October 24, 2014

Re: 401 Water Quality Certification Application Response to Technical Comments
Vrooman Road
Corps Public Notice No. NA
Ohio EPA ID No. 144408

Locations of culvert replacements/extensions

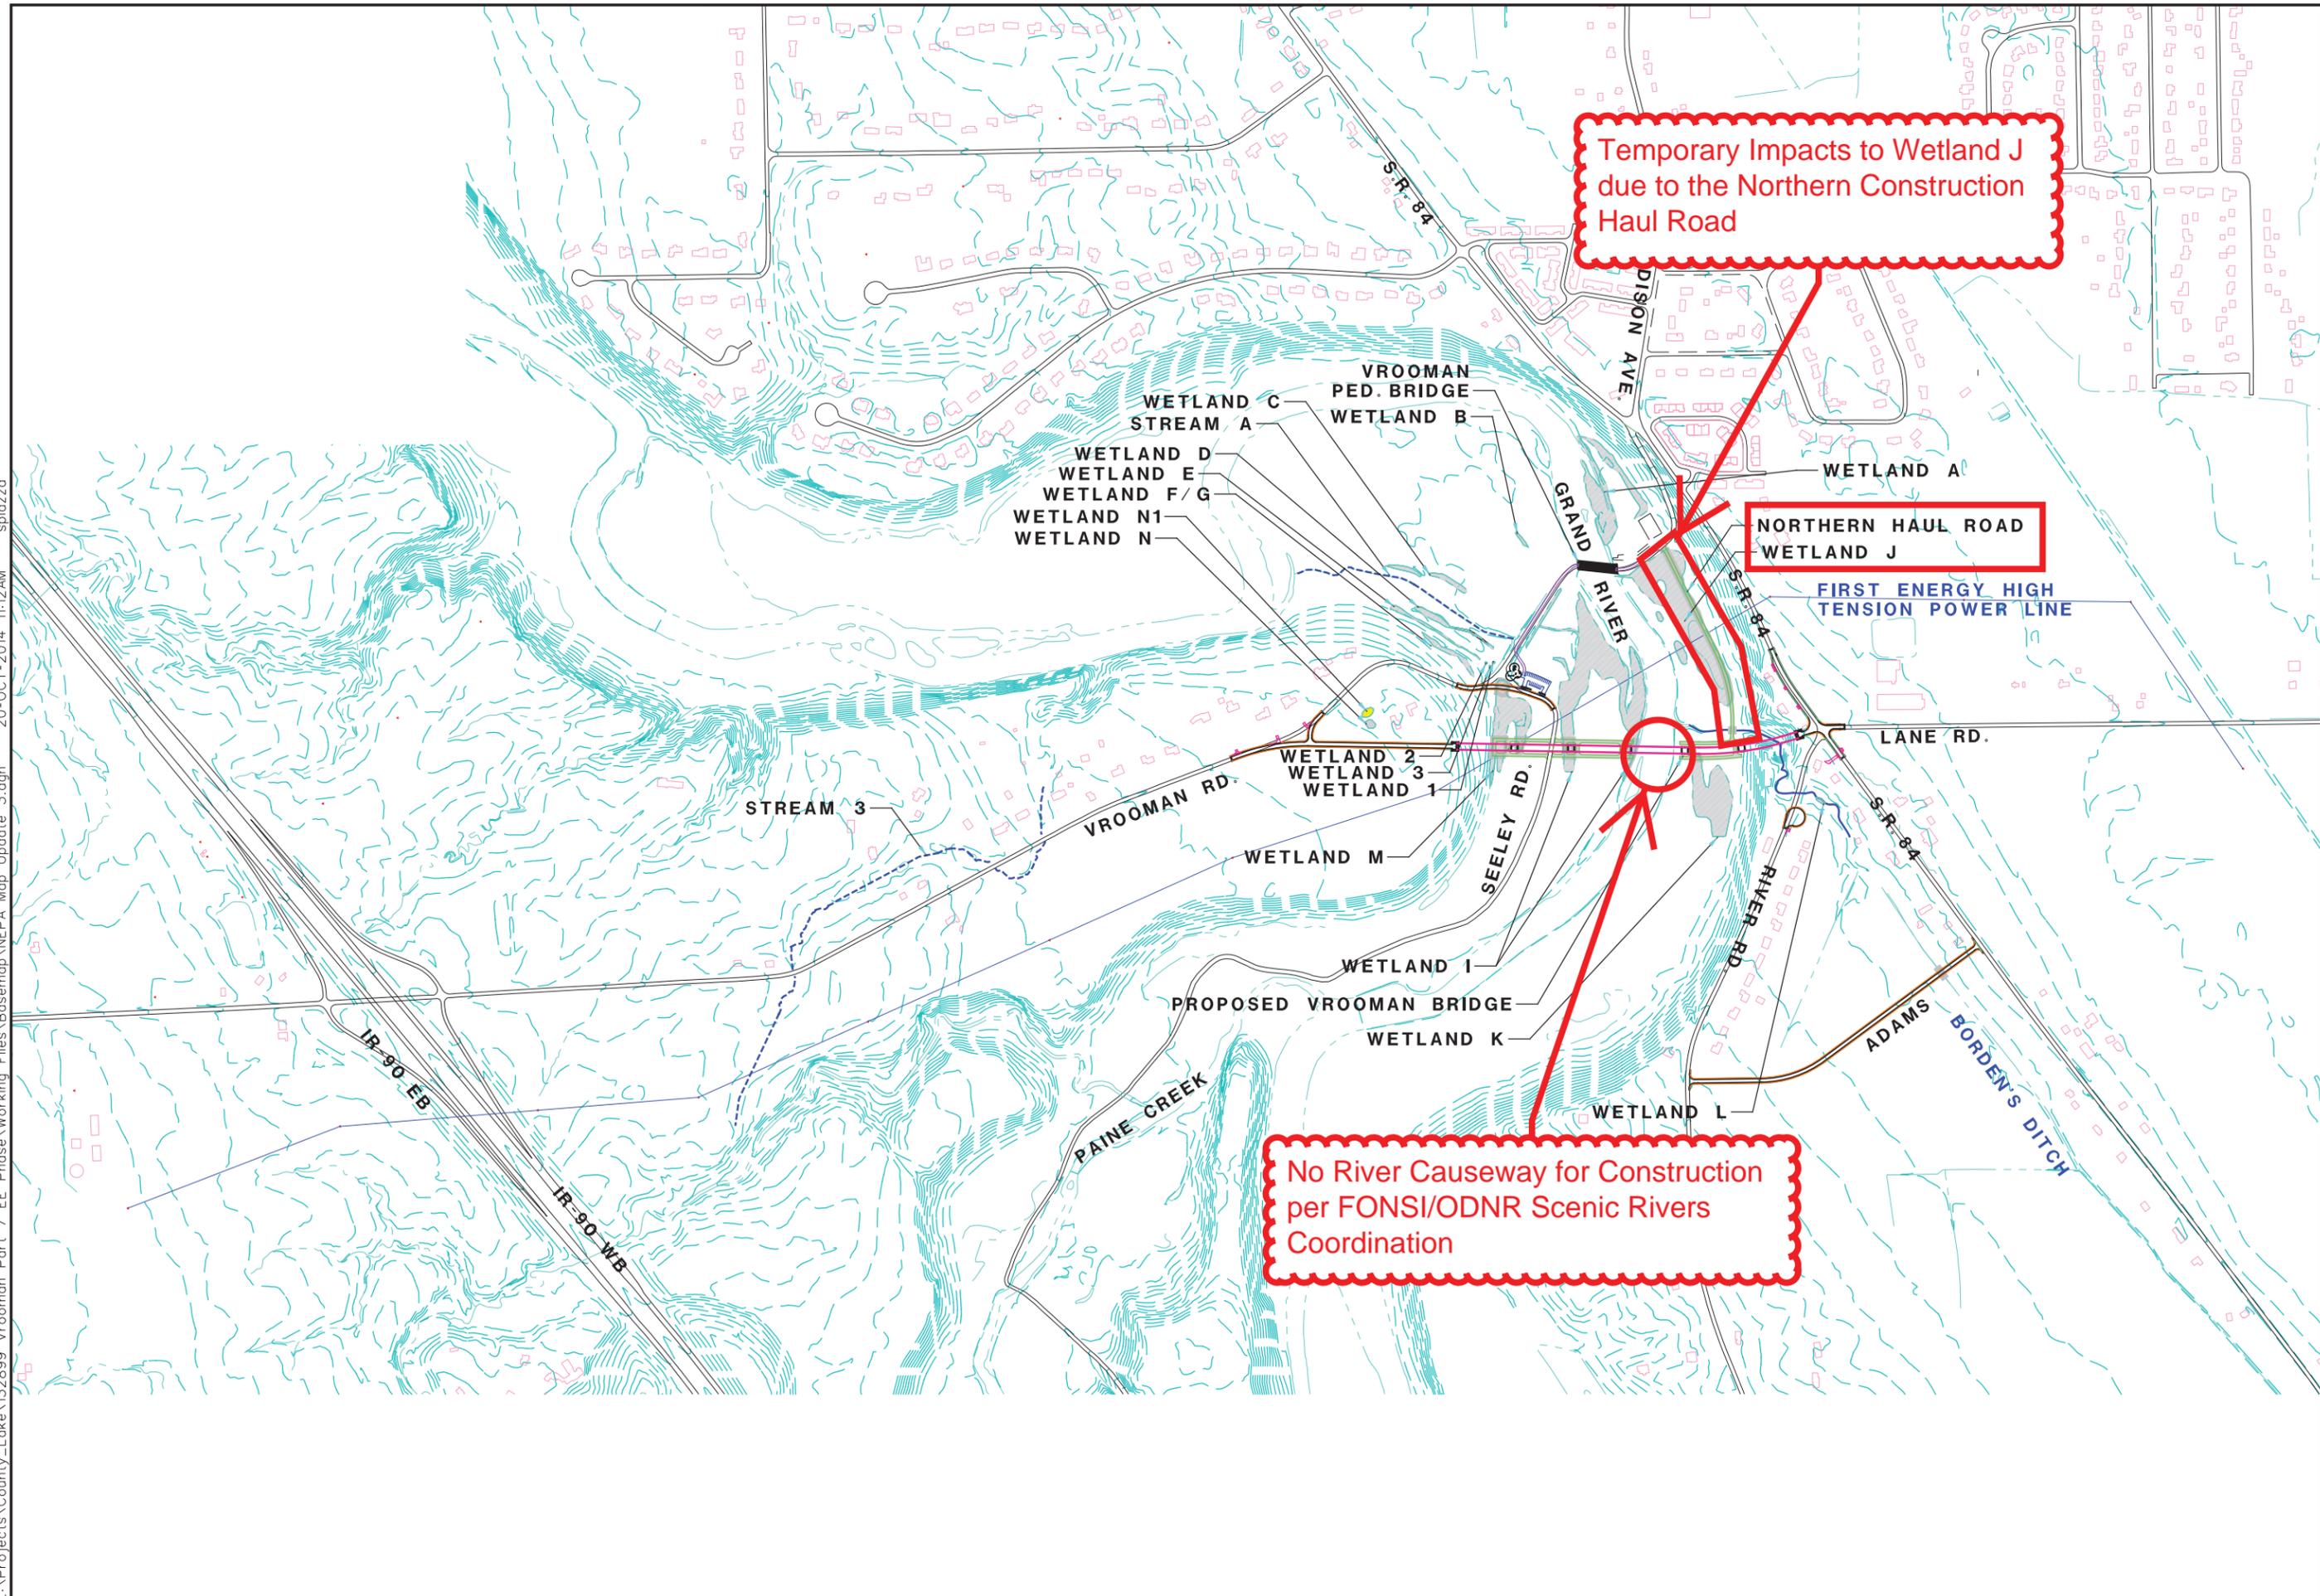
- 1. Being persnickety, on the preferred and minimum deg alternatives, aren't there impacts from I-90 north to the bridge on Vrooman where the road will be straightened, or is all that flat and gentle-curved enough not to be a problem? If that is the case, could you please resend the alternatives maps zooming more into the project?**

There will be no straightening along Vrooman Road. The only impacts to aquatic resources from I-90 north to the bridge on Vrooman Road include the replacement and extension of three existing culverts on Stream 3. A schematic plan with these locations highlighted is attached. Plan and profile sheets for each of the culvert extensions were included in Figure 4 of Appendix B of the Section 401 Application submitted August 7, 2014. The impacts to Stream 3 are the same for both the Preferred and Minimal Degradation Alternatives.

PREFERRED ALTERNATIVE
PROJECT STUDY AREA

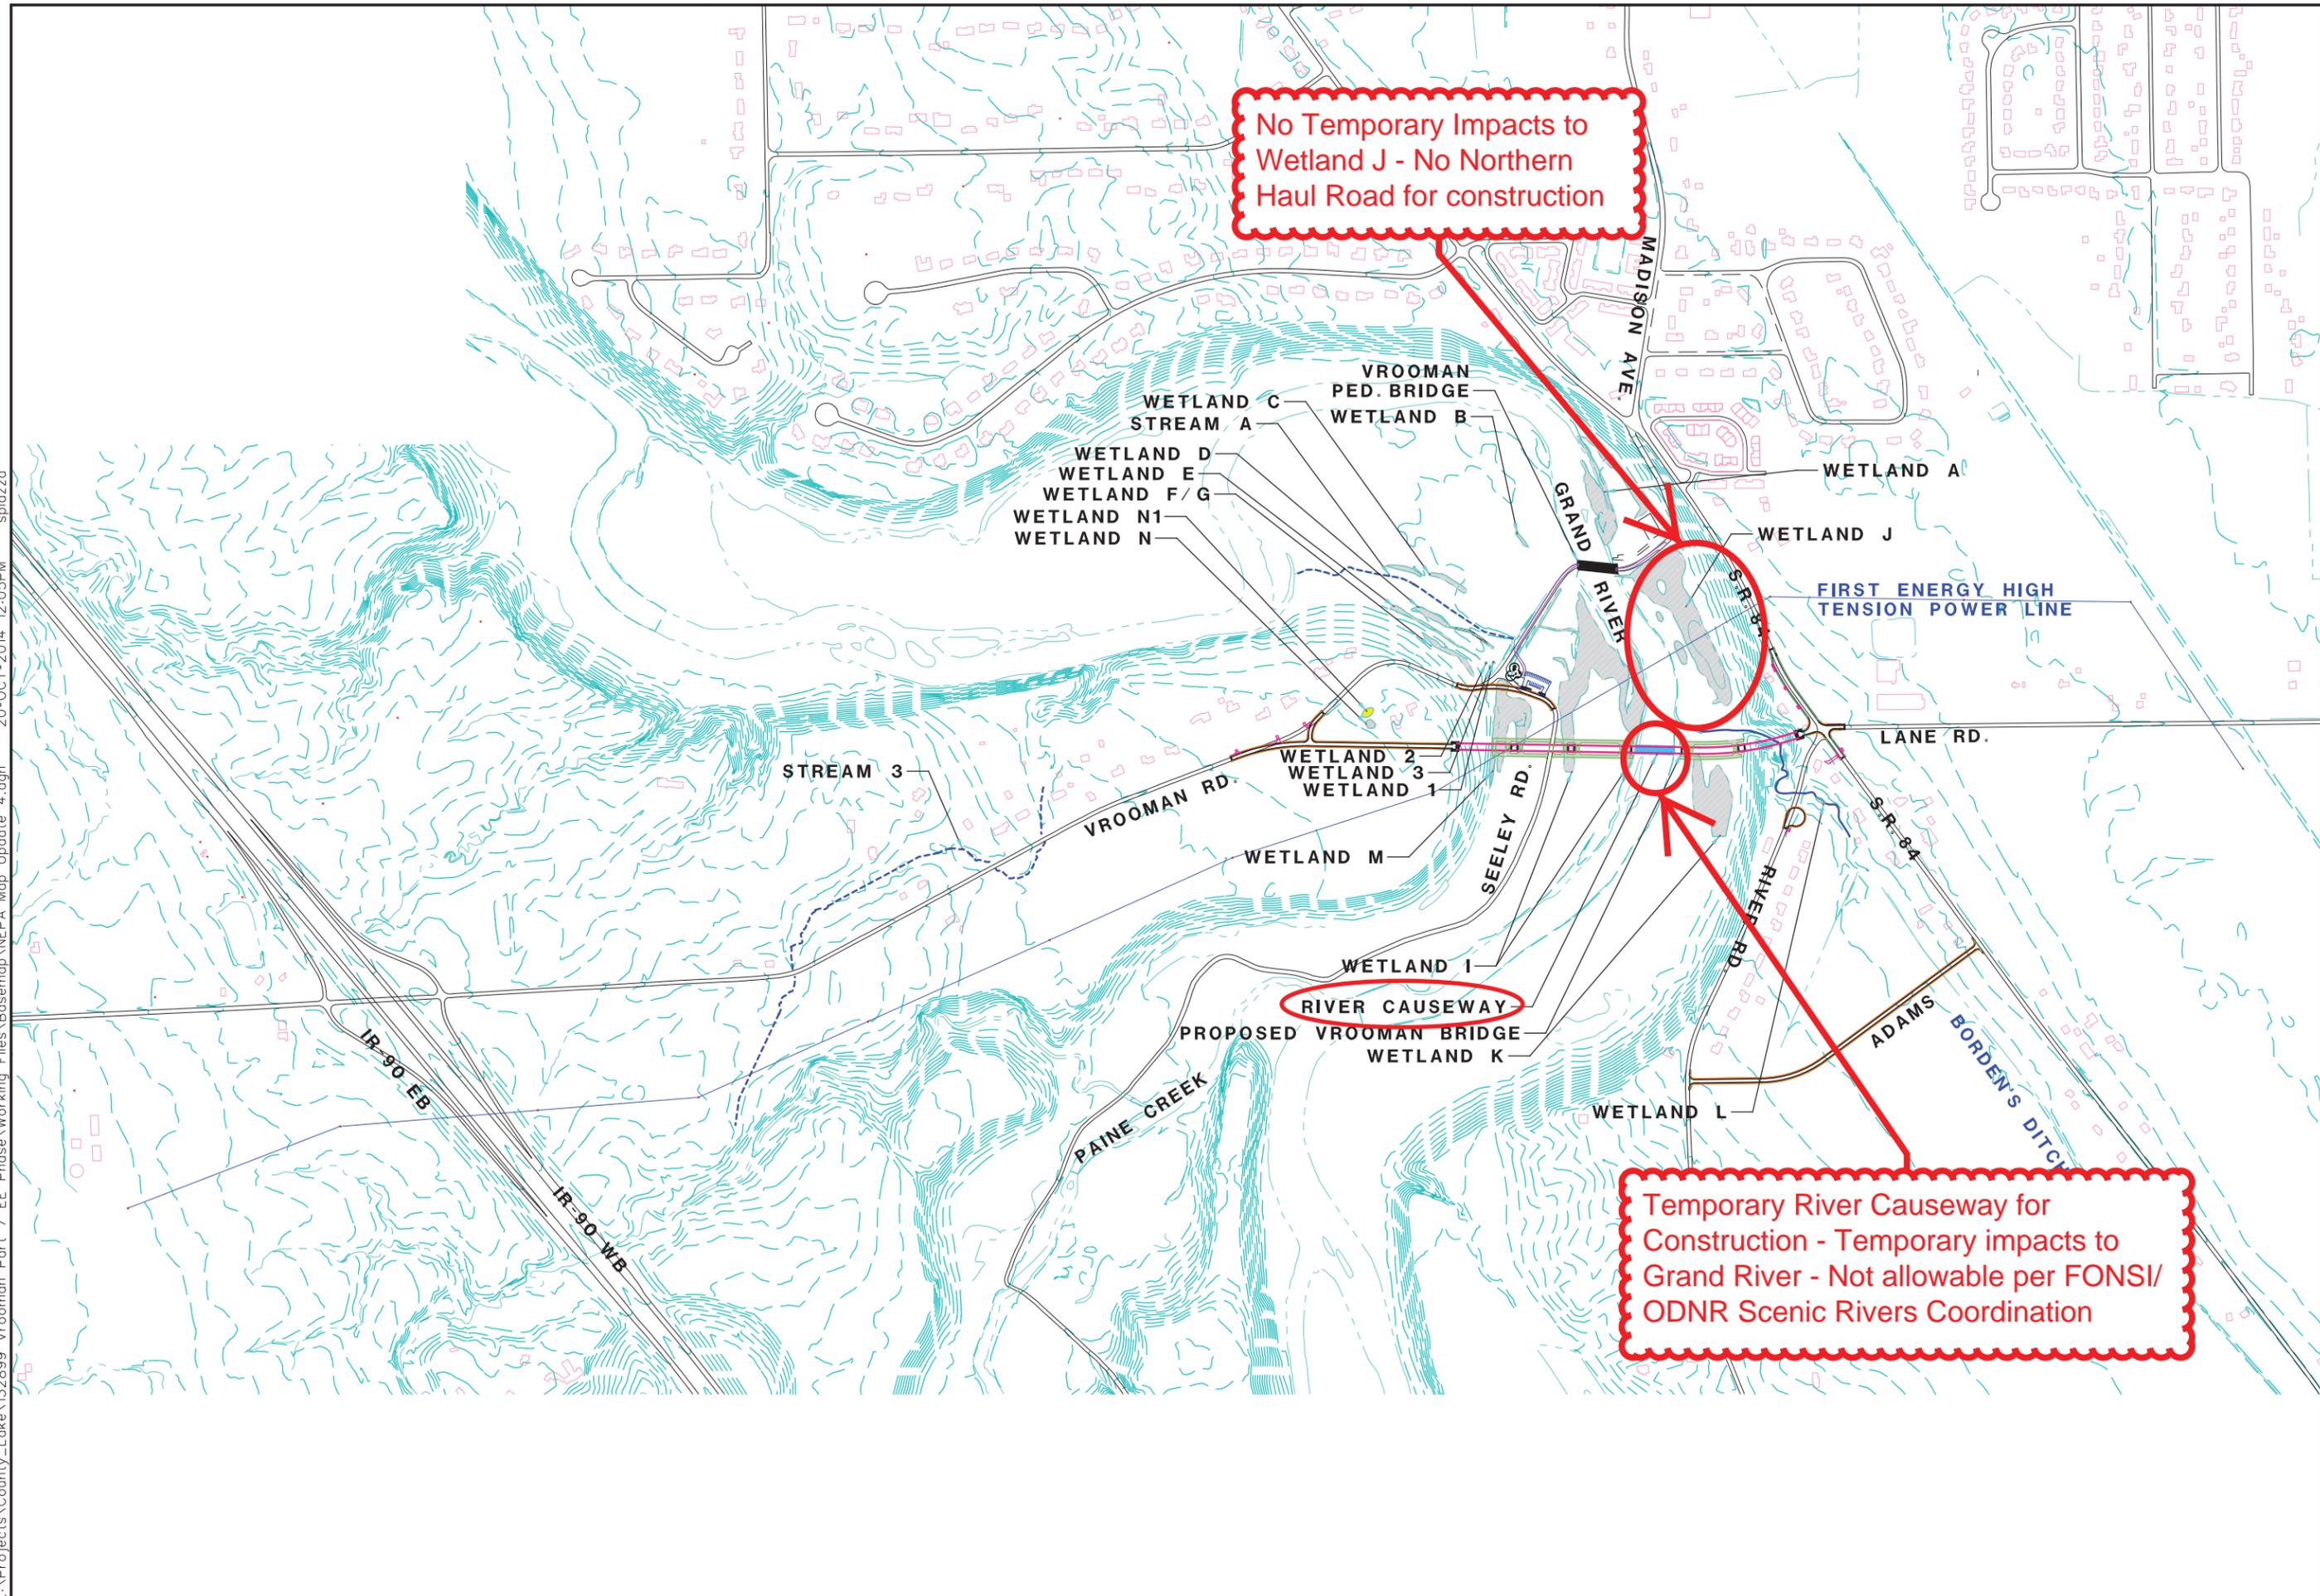
4. I have spent a few more moments looking at the Preferred and Minimum Degradation drawings. The purpose of these drawings are to demonstrate pictorially the project, and to draw attention to the differences between the two options. I really cannot see a difference between the two. If you need to provide a cross-section or two to tell the story, that's fine. But I really need to be able to differentiate pictorially between the preferred and minimum deg alternatives.

The only differences between the two alternatives include the removal of the Northern Haul Road and the addition of a river causeway in the Minimal Degradation Alternative. We have edited the previous figures highlighting these differences between the two alternatives. Please note that plan and profile sheets for the Preferred Alternative are included as Figure 3 in Appendix B of the Section 401 Application. Plan and profile sheets for the Minimal Degradation Alternative are included as Figure 5 in Appendix B of the Section 401 Application.

Temporary Impacts to Wetland J due to the Northern Construction Haul Road

NORTHERN HAUL ROAD
WETLAND J

No River Causeway for Construction per FONSI/ODNR Scenic Rivers Coordination

No Temporary Impacts to Wetland J - No Northern Haul Road for construction

Temporary River Causeway for Construction - Temporary impacts to Grand River - Not allowable per FONSI/ODNR Scenic Rivers Coordination
